REMARKS

Objections to the Drawings

In the Drawings

FIG. 1 - Prior Art

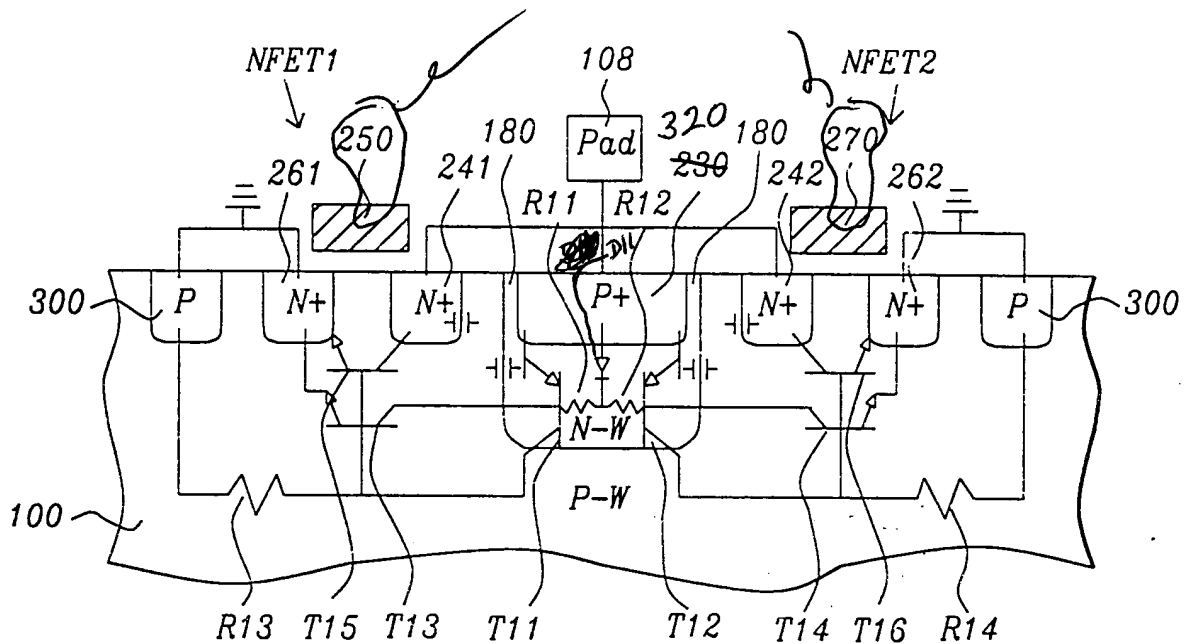
The Office Action objects to the drawings due to various informalities. Specifically, several reference characters used in the drawings were not mentioned in the specification and *vice versa*. In this regard, Applicants have provided replacement drawing sheets to be entered and has amended the specification as indicated above. Applicants respectfully assert that no new matter has been added. Specifically, Applicants have:

removed reference characters 250 and 270 in the amended Fig. 1;

replaced reference character 230 with reference character 320 such that the drawing is consistent with the description;

added reference character D11 to designate the diode in Fig. 1;
